MEMPHIS AND SHELBY COUNTY OFFICE OF PLANNING AND DEVELOPMENT
STAFF REPORT **15**

CASE NUMBER: P.D. 09-307 **L.U.C.B. MEETING:** May 14, 2009

DEVELOPMENT NAME: Community Capital Planned Development

REQUEST: Single tenant office building

Site Plan

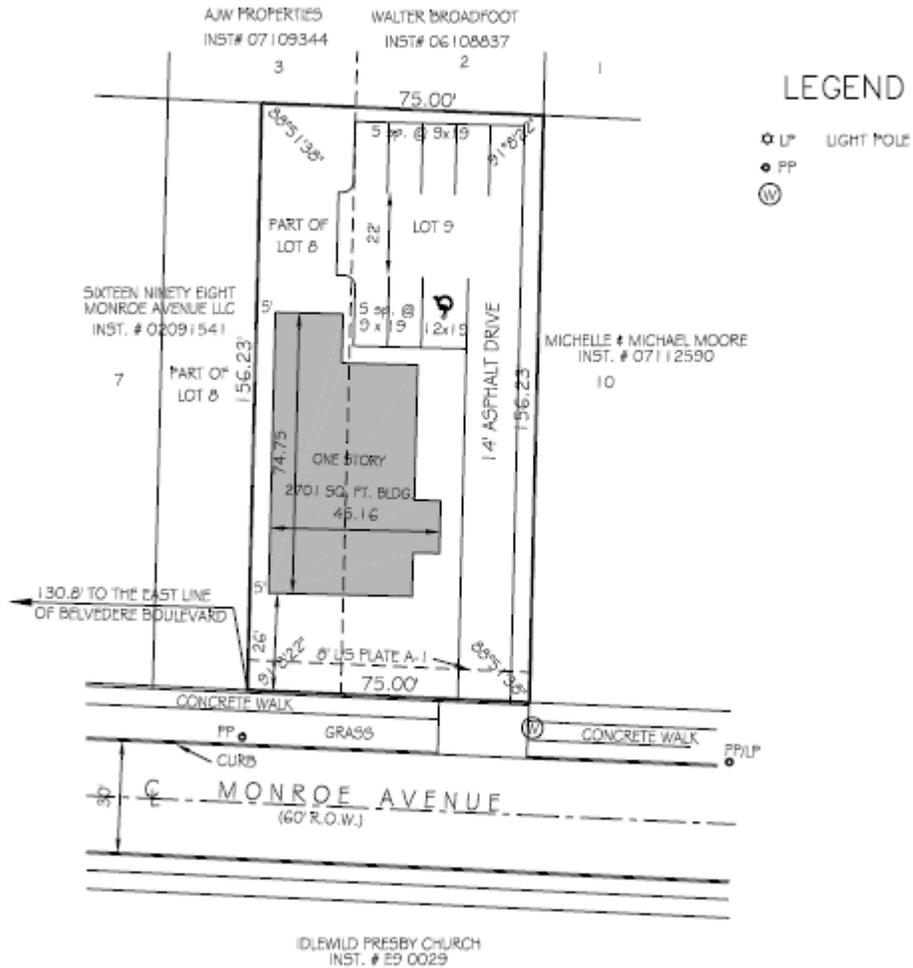
Site Plan - The existing site, which is vacant, is a former residential lot which is limited in both width and depth for non-residential development. This is an important consideration in evaluating the proposed site plan for required parking and access.

The Site Plan indicates that the building footprint is just over 2,700 square feet. The Parking Regulations require one space for every 300 square feet of building, or 9 spaces. The site plan shows 7 spaces plus one space for the handicapped for a total of 8 spaces.

A standard two-way drive aisle is 22 feet although a private drive may be permitted at 18 feet. The applicant's proposal shows a 14 foot wide drive.

With a lot depth of approximately 150 feet, it will not be difficult for cars attempting to exit or enter the parking area to see an opposing car and make arrangements to let the opposing car to pass. Widening the drive another 4 to 8 feet will only serve to add more pavement and call attention to this site as something other than residential which in contradiction to what is trying to be achieved by the filing of the Planned Development application.

One change does need to be made to the site plan. In the area at the terminus of the drive aisle,

the aisle needs to be extended to the west to allow for proper room for a vehicle to turn around.

The design and site plan for this PD are very good with the parking in the back and the entry of the structure on the façade addressing the street. It would be best if the new structure front set back is in line with the adjacent existing structure. This will create a consistent façade setback for the rest of the vacant properties on the street.

- A. Access to the site shall be via the 14 foot wide drive and curb cut as shown on the submitted plan.
- B. The number and location of parking spaces shall be as shown on the submitted plan.
- C. The drive aisle specifically serving the parking shall be extended to the west at least 10 feet to provide for a turnaround
